MIRACLES CENTRAL DESIGN REVIEW

DESIGN REVIEW SUMMARY

10.16.2014

GROUND FLOOR PLAN - NEW

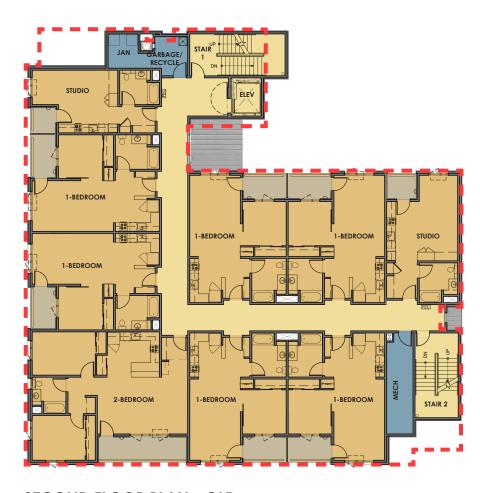
- PRIMARY MASSING IS GOOD
- REDUCE BUILDING SETBACK AT NW AND SE CORNERS
- NEED A BETTER TERMINATION OF TOP FLOOR WITH REST OF MASSING
- SIMPLIFY FORM OF TOP FLOOR. FEWER INS/OUTS. MATCH MASSING DIAGRAM
- LOOK INTO LARGER AND MORE REGULAR WINDOW OPENINGS AT SW CORNER
- BUILDING ENTRIES ARE TOO RECESSED AND THERE ARE TOO MANY INS/OUTS

GROUND FLOOR PLAN ADJUSTMENTS

SOUTH ELEVATION

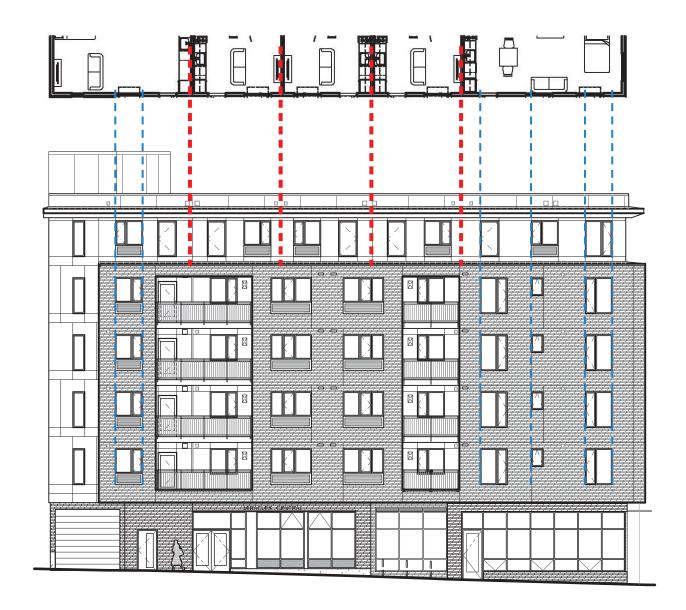
UNIT DEMISING WALL
WINDOW ALIGNMENT

VIEW OF COURTYARD FROM ENTRANCE

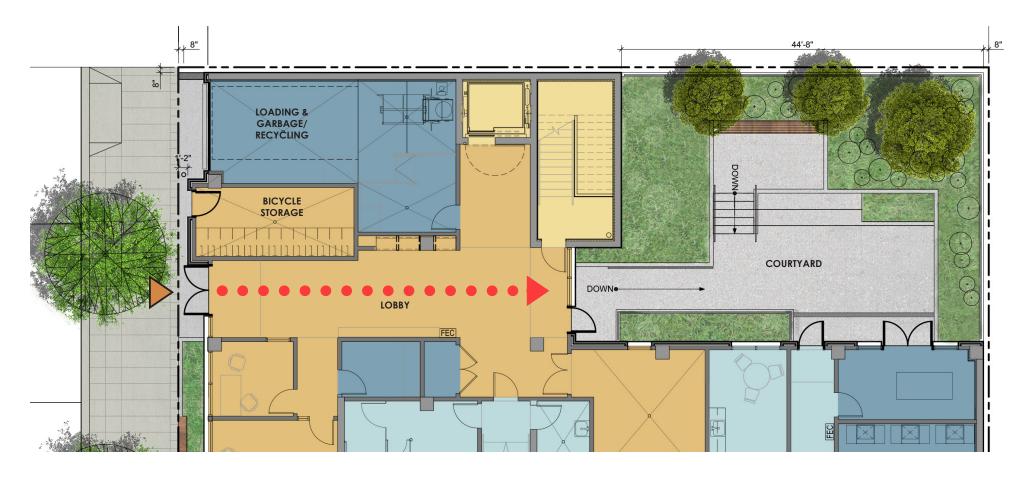
- RESIDENTIAL ENTRANCE SHOULD BE LARGER AND EASIER TO IDENTIFY
- STRENGTHEN LINE OF SIGHT TO COURTYARD FROM RESIDENTIAL ENTRANCE
- PROVIDE BETTER PEDESTRIAN WEATHER PROTECTION
- BETTER UNIFY GROUND FLOOR WINDOWS
